ORIGINATION FORM

Proposed Revisions to a Standard Plans Index
(Please provide all information – Incomplete forms will be returned)

Index Number: 430-090
Sheet Number (s): 1 of 1
Index Title: Safety Modifications for Endwalls

SHEET 3: STEEL GRATE

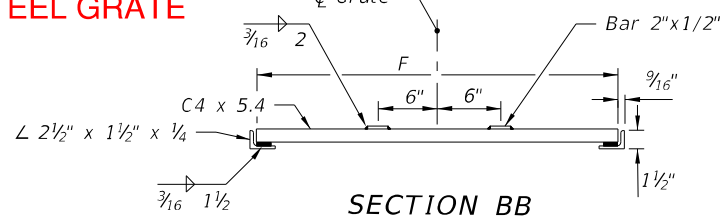
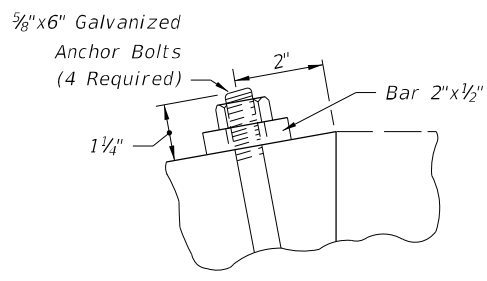
Welds shown in additional Details for clarity

SHEET 2: Split into Dimensional and Reinforcing Details

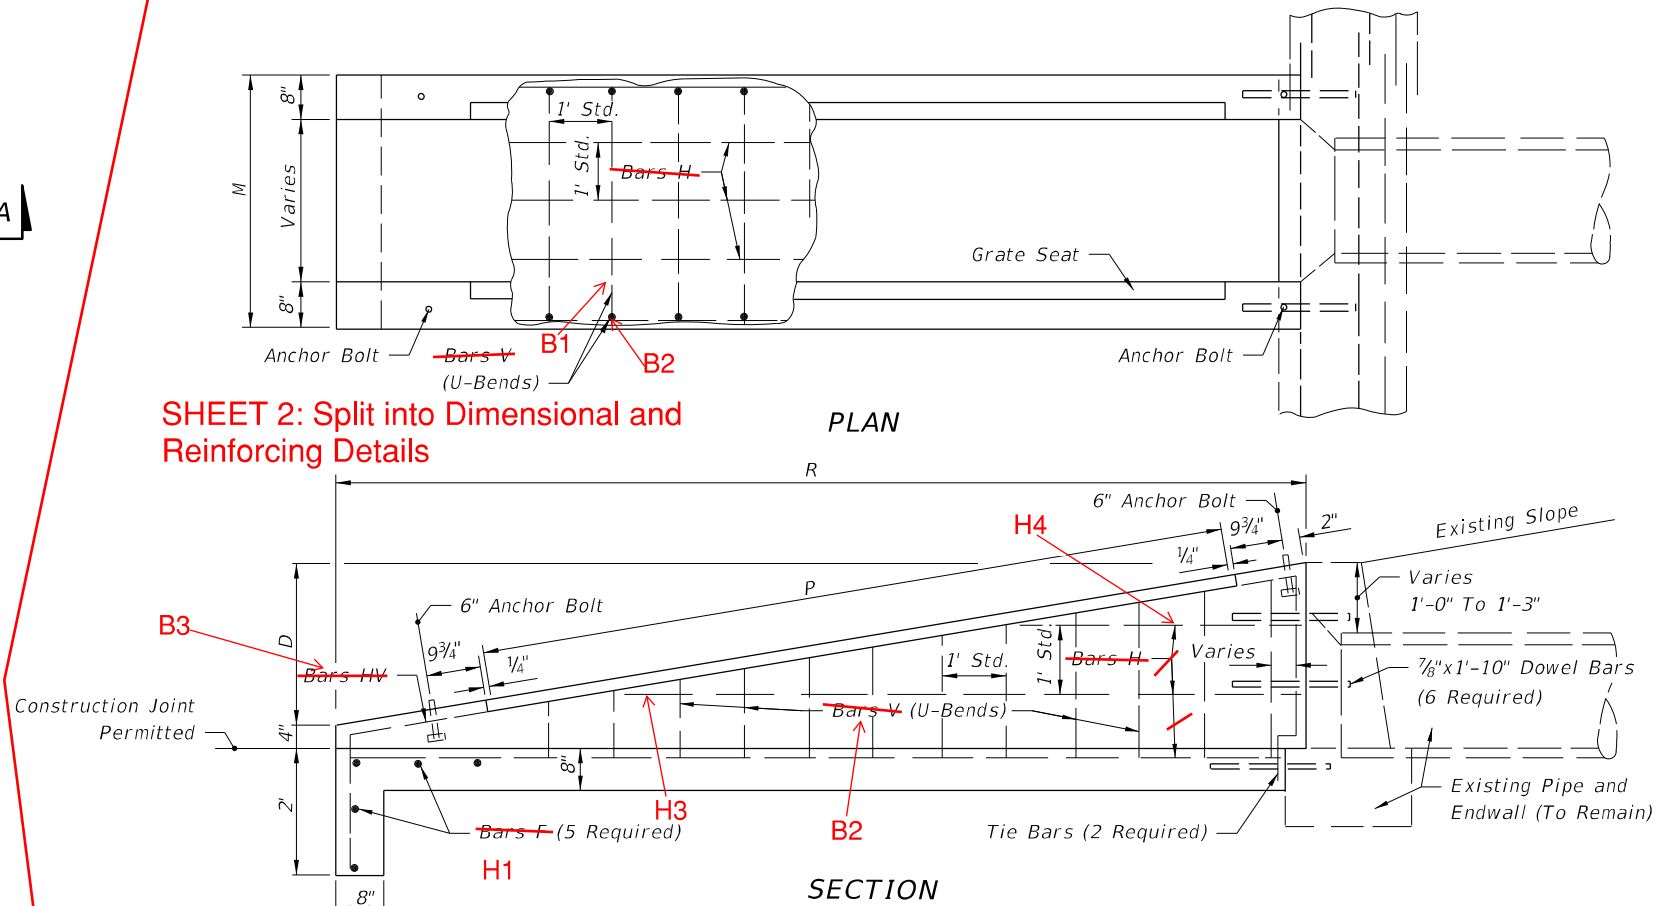
1. For use criteria see "Steel Grating Use Criteria" Index 430-011. **Design Manual SHEET 1**
2. Grates shall be ASTM A242, A572 or A588, Grade 50 steel, and galvanized in accordance with Section 975 and 425-3.2 of the Standard Specifications. **Moved to Specification**

5. Drill 1 1/4" holes 8" deep with a rotary drill in existing endwall for dowel bars. Holes shall be thoroughly cleaned prior to installing Adhesive-Bonded Dowels. **Moved to Specification**

ENDWALLS FOR 1:4 AND 1:6 SLOPES

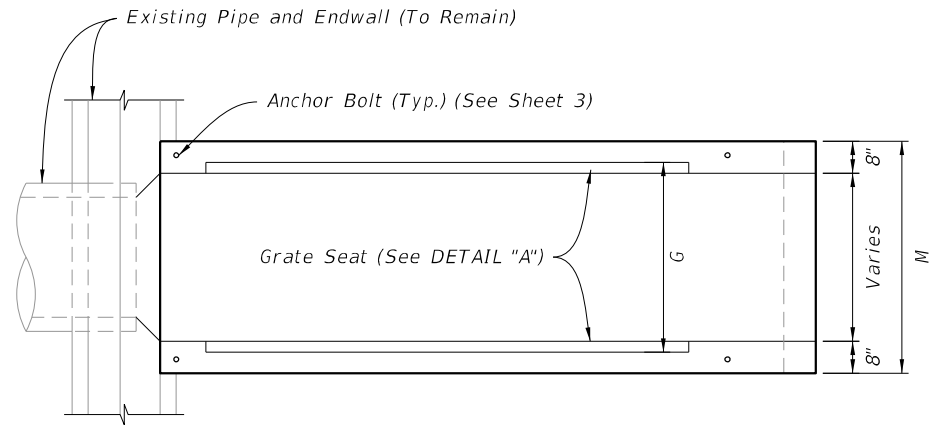
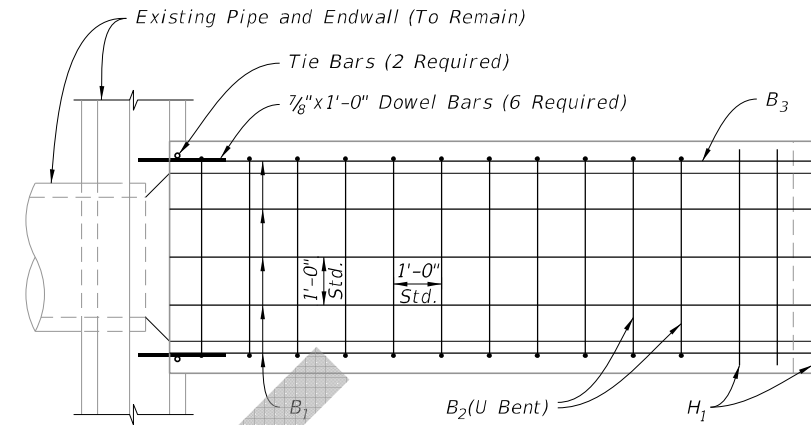
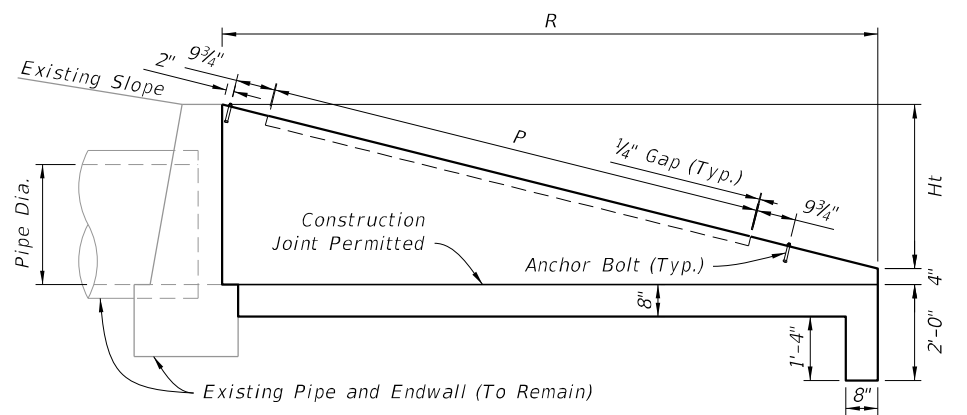
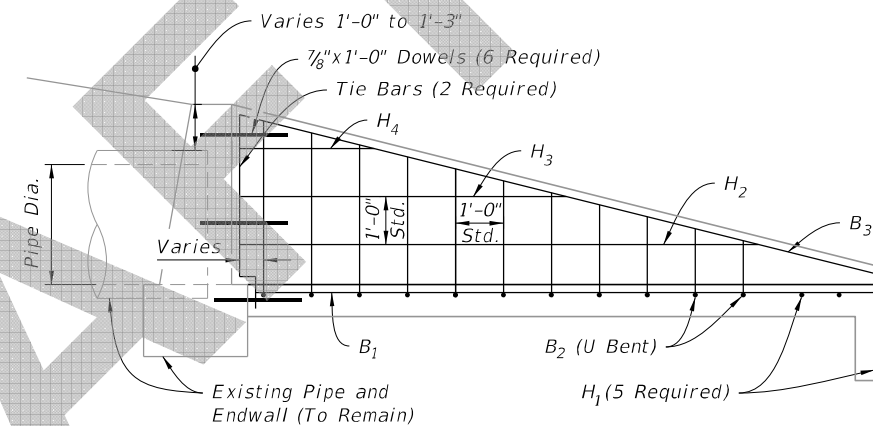
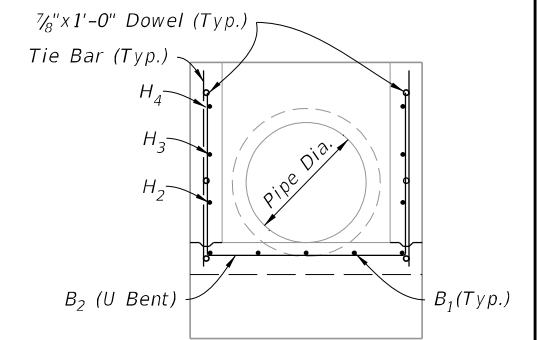
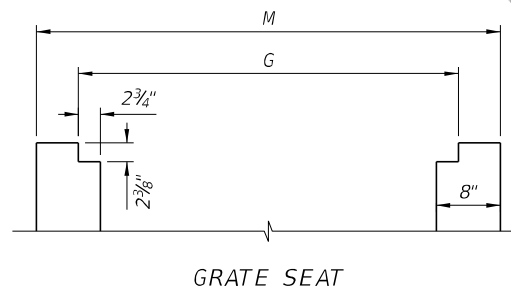
Sheet 2: Detail split into Dimensional and Reinforcing Details.
